GENTRY HOMES
6358 CONLEY ROAD, CONCORD, OHIO. 44077

SITEPLAN
SUBLOT NO. 1 CALLOW ROAD, LEROY, OHIO. 44077

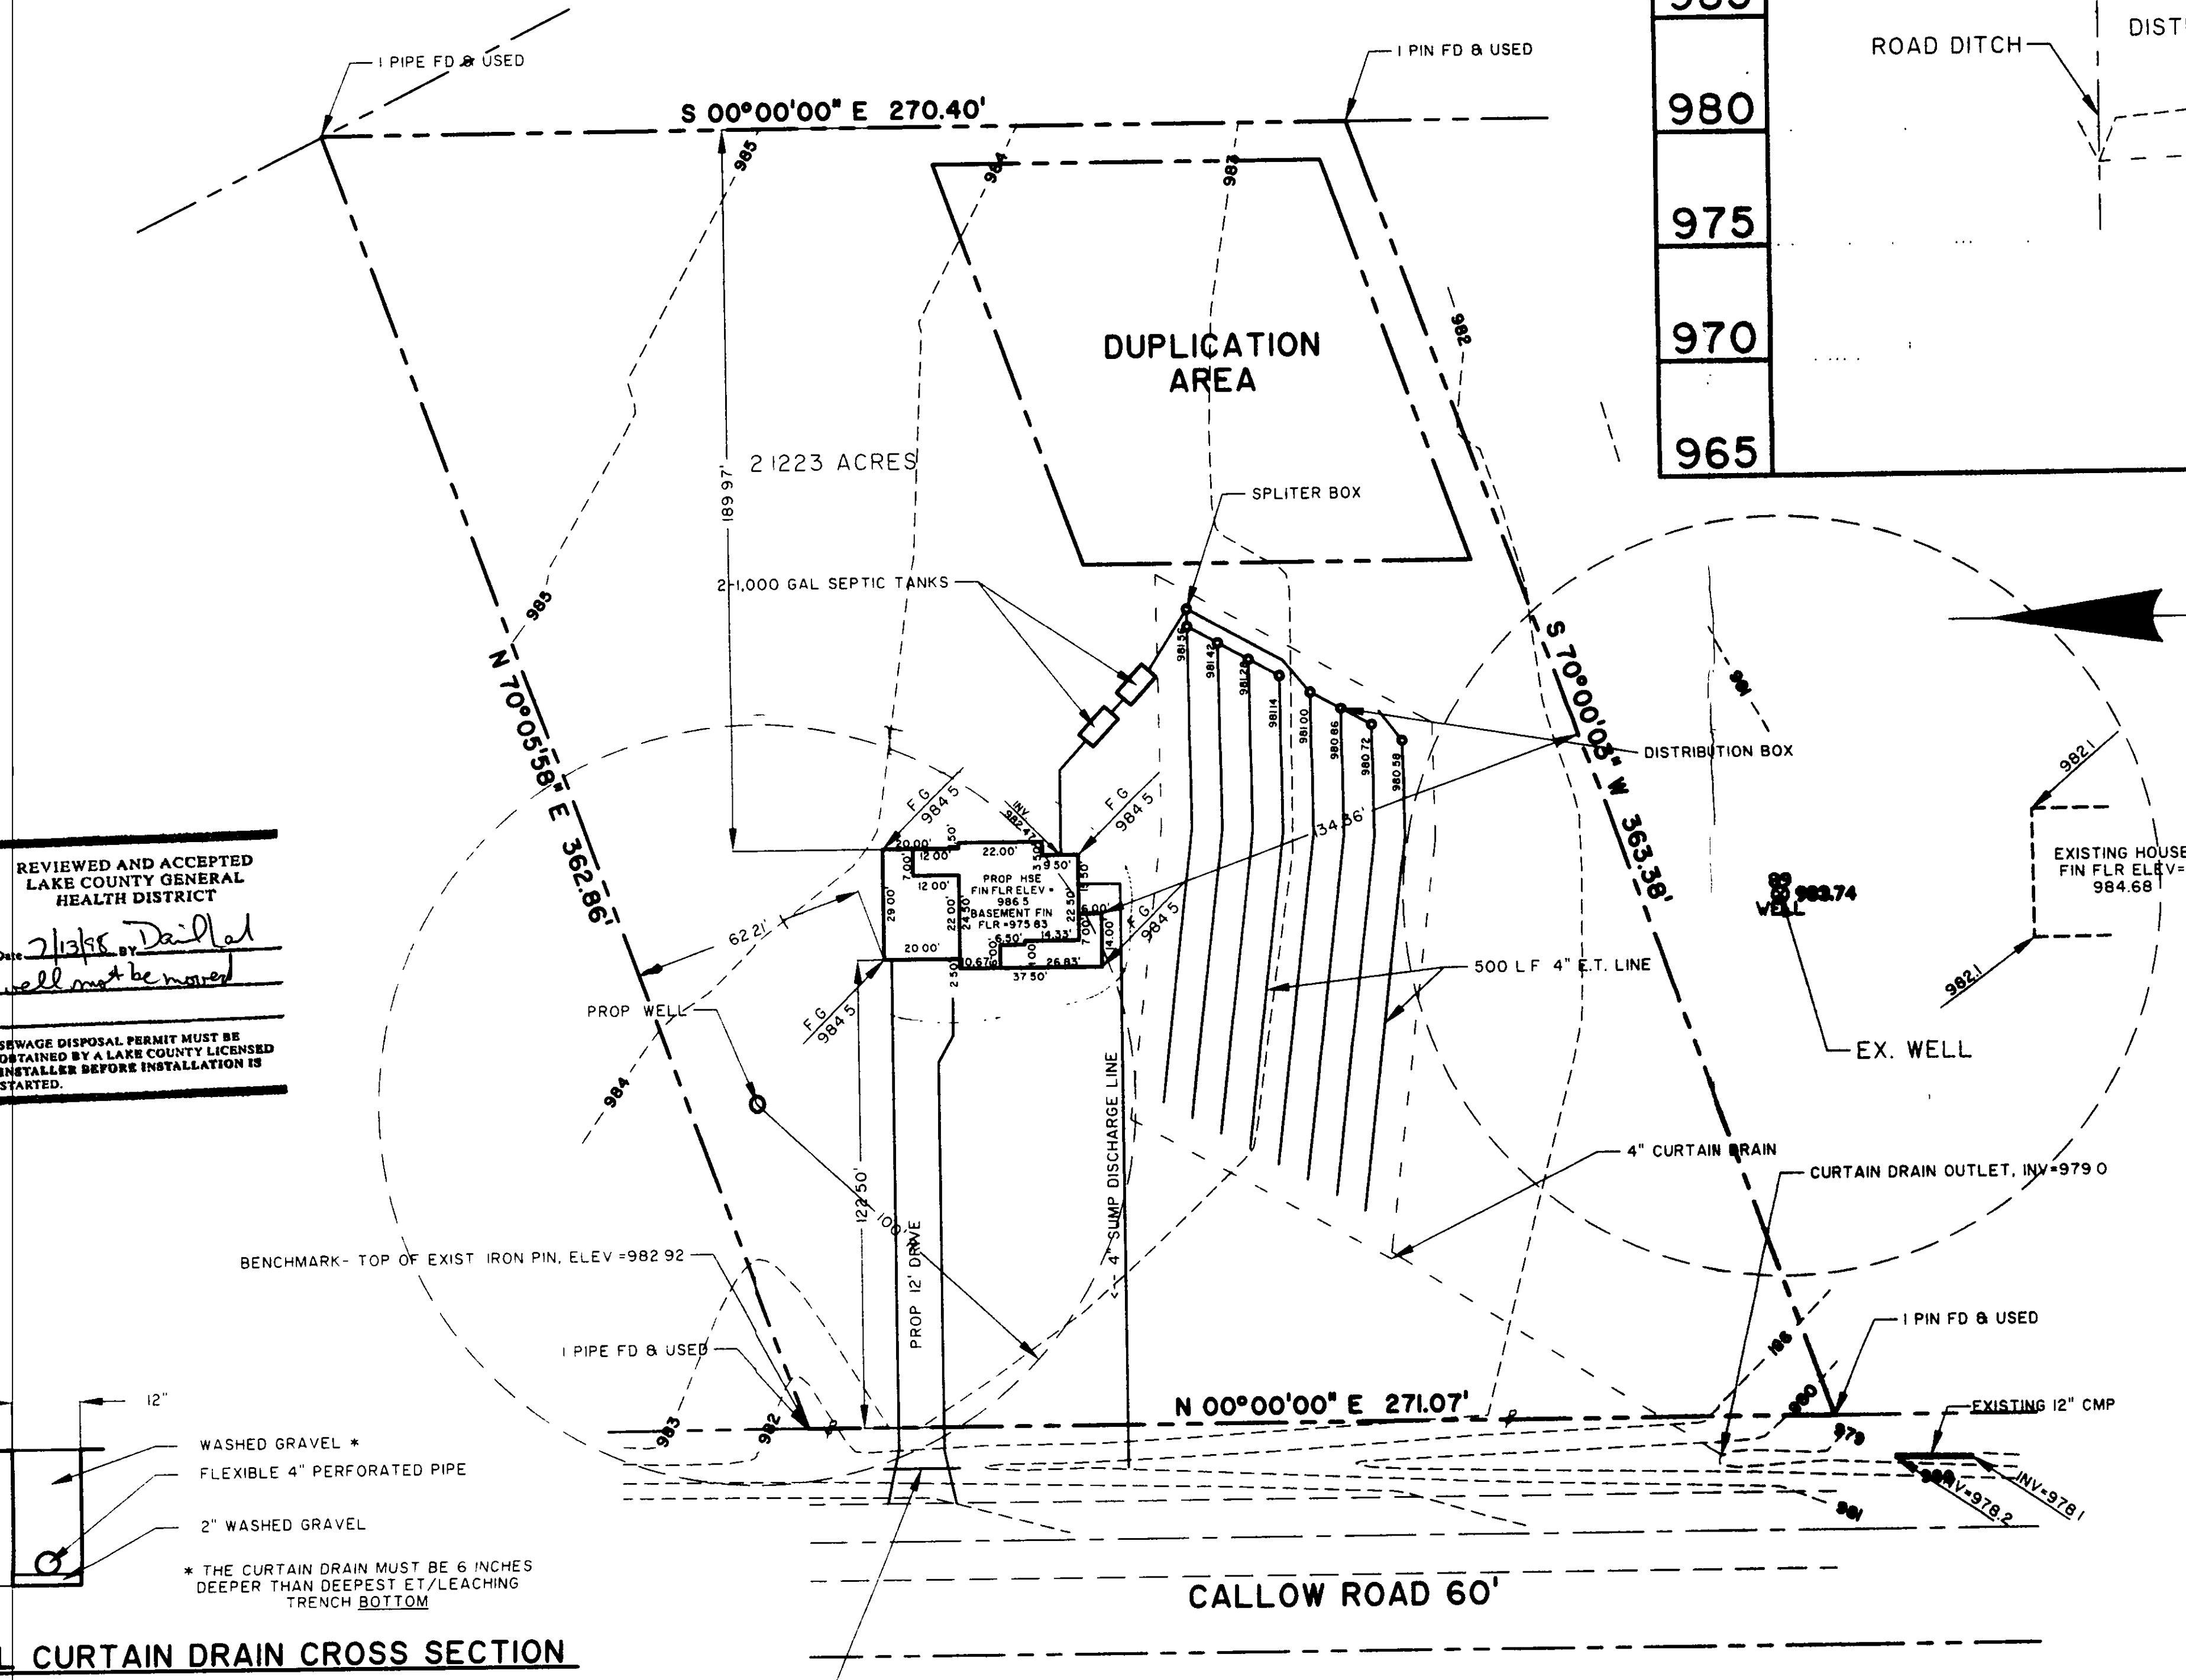
REVIEWED AND ACCEPTED
LAKE COUNTY GENERAL
HEALTH DISTRICT
2/13/98 Dailal
well must be moved
SEWAGE DISPOSAL PERMIT MUST BE
OBTAINED BY A LAKE COUNTY LICENSED
INSTALLER BEFORE INSTALLATION IS
STARTED.
